Evaluation of the Pool Temperature
Limit for the Ramshead SRV Discharge Device

I. Introduction and Summary

FIGURE 1 STEAM MASS FLUX

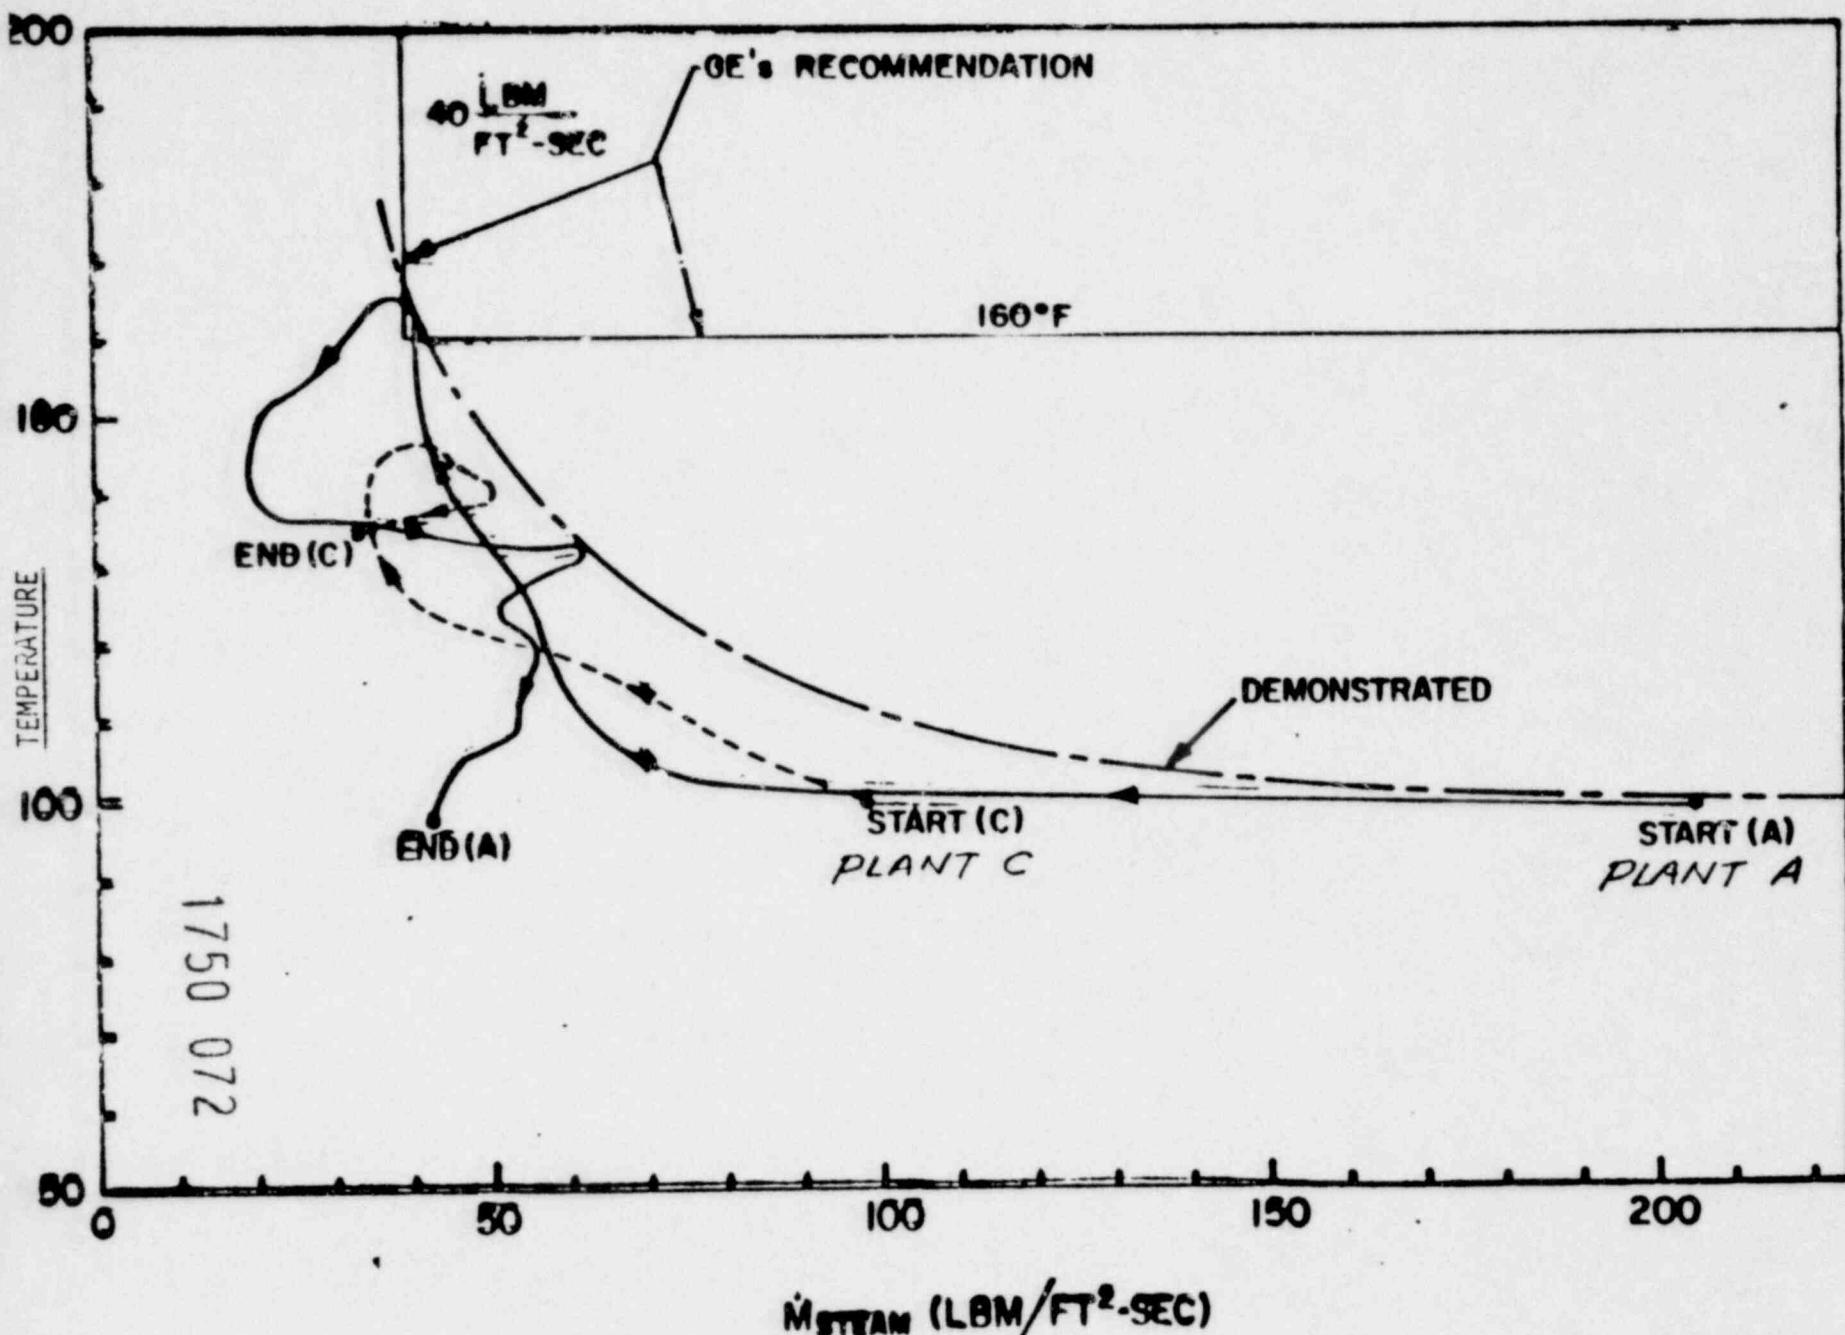
Figure 1 shows the loci of the Plant A and C events on a plot of pool temperature versus SRV steam mass flux during blowdown. Also shown in the figure is the GE proposed pool temperature limit. It is clear that the plants experienced SRV discharges far below GE's proposed temperature limit at virtually all mass fluxes except the lowest. Thus, their experience does not provide support for the higher mass flux at GE's proposed elevated temperature of 160°F.

Figure 2 Quencher and Rams Head Schematic

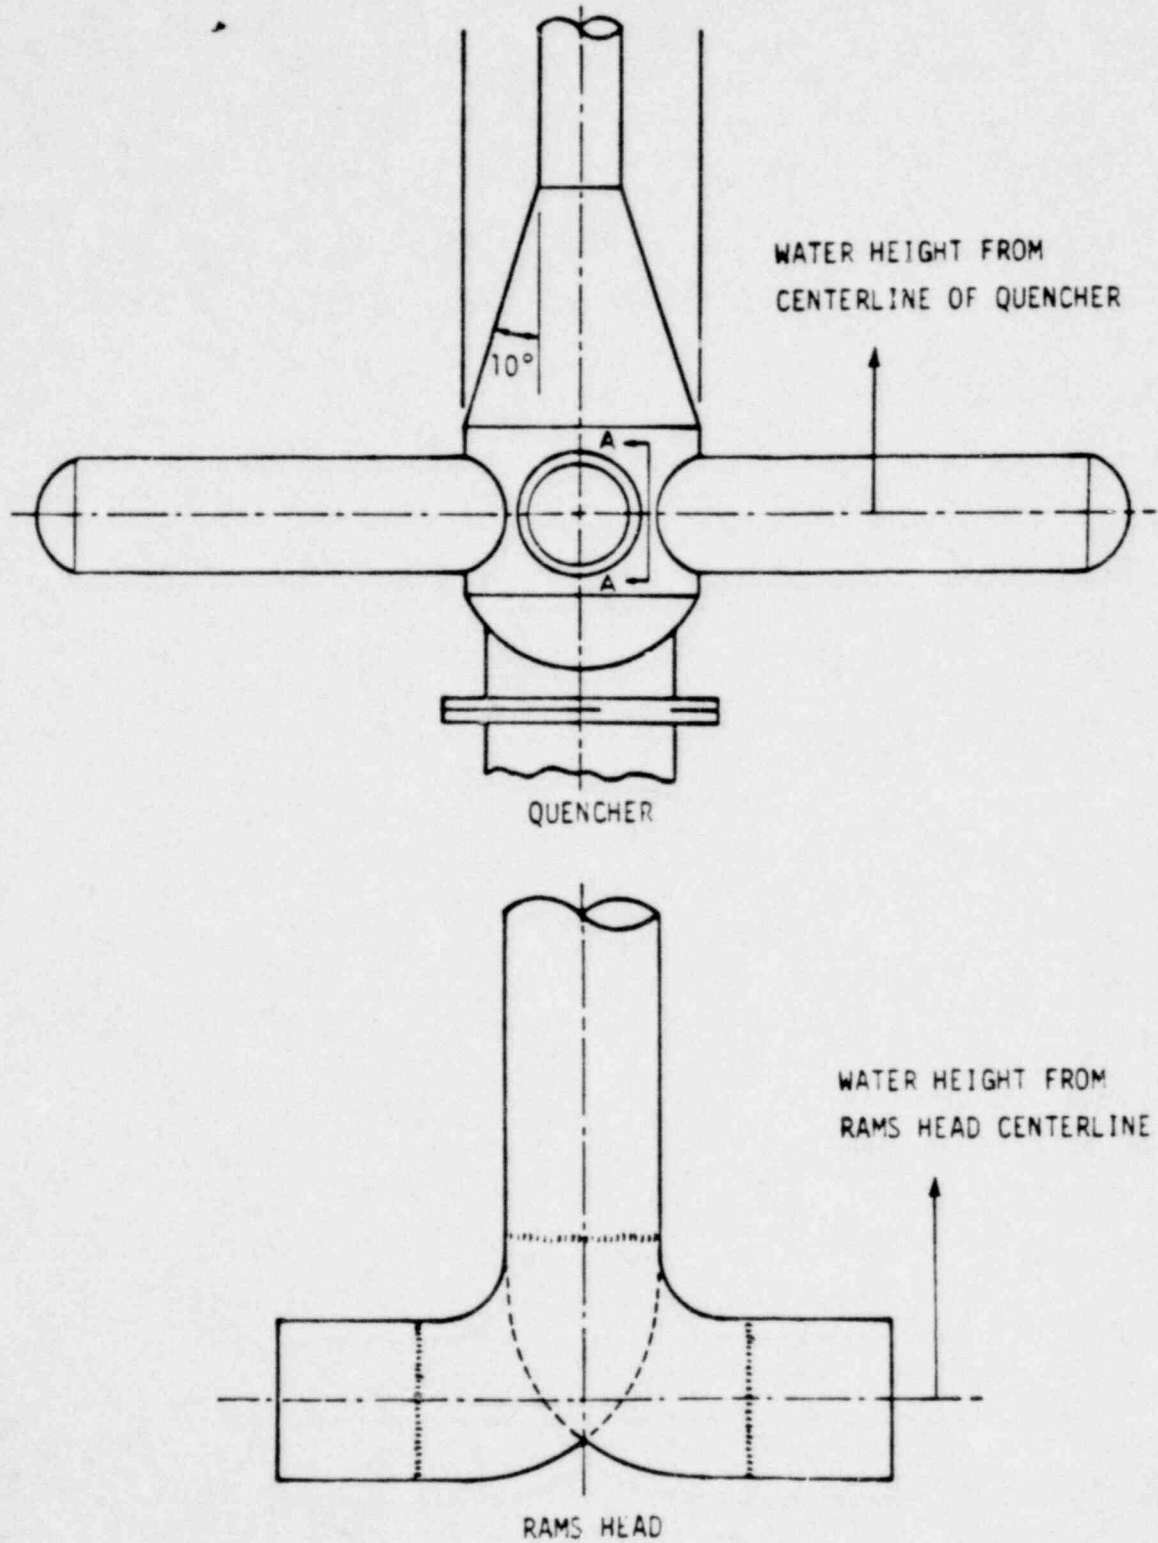
Figure 2 shows the configuration of a typical cross quencher, which is currently used by all Mark III containments. It has four arms. Each arm is perforated with several rows of small holes. The tip of the arm is plugged. It is about 10 feet long from tip to tip. Steam flows through the hub and is distributed among the four arms and discharged into the pool. The quencher device produces a cloud of air or steam mist, whereas the ramshead produces large bubbles.

As a result, the magnitude of the quencher air clearing load is reduced by a factor of two to four. In addition, steam condensation instability did not occur although the pool temperature approached the boiling point. The capability of the quencher to perform its function at elevated temperatures is also important in the event of an ATWS since elevated pool temperatures for the BWR 4 & 5 designs are expected to approach the boiling point.

Figure 3 Mark III 238-732 Standard Plant 19 S/R Valves Wall Pressure at 00 to 3600

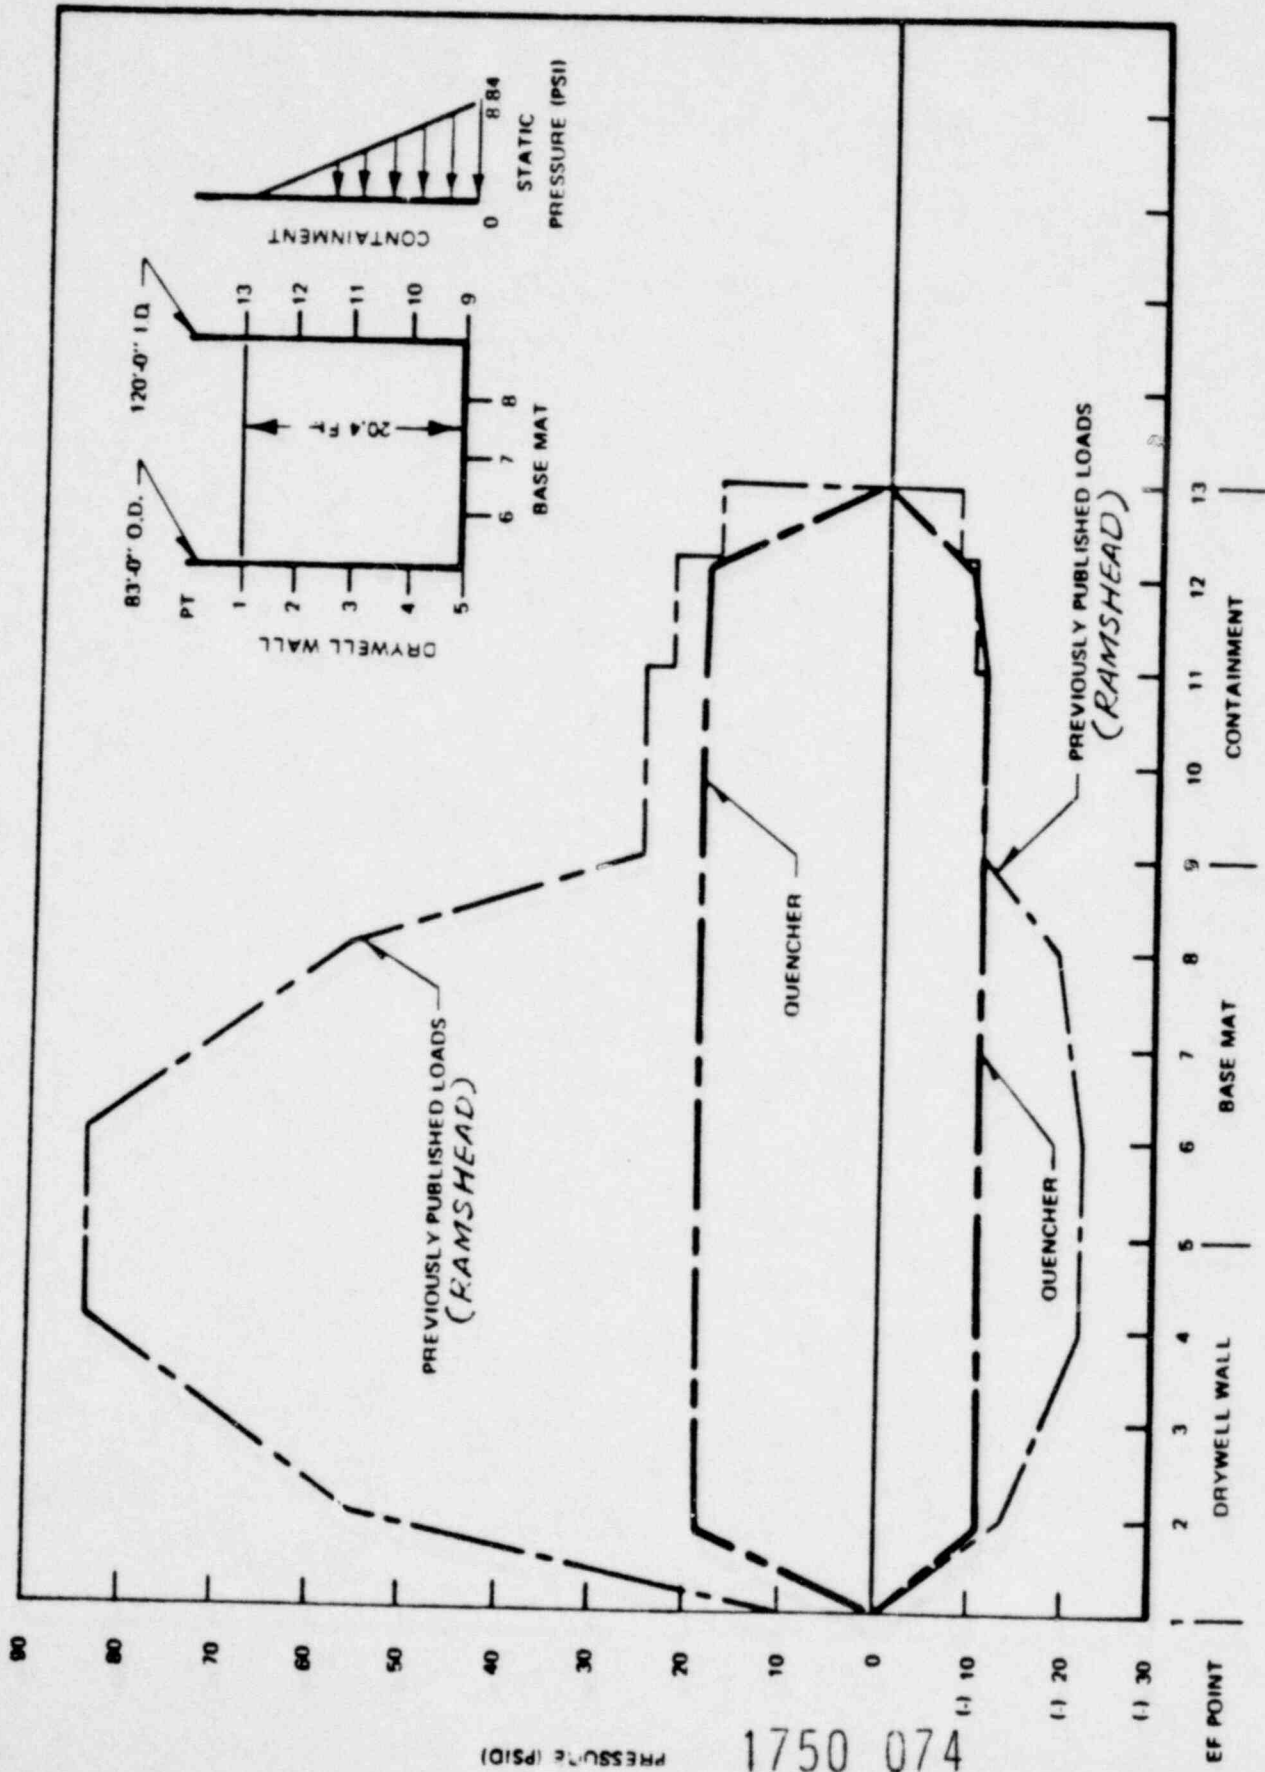
Figure 3 (Ref. 4) shows the comparison of hydrodynamic loads for quencher and ramshead devices for a 238 GESSAR Mark III plant. The quencher device, in general, reduces the loads on the containment structure substantially, the magnitude of the load reduction being dependent on the quencher configuration and its relative location to the adjacent structures.
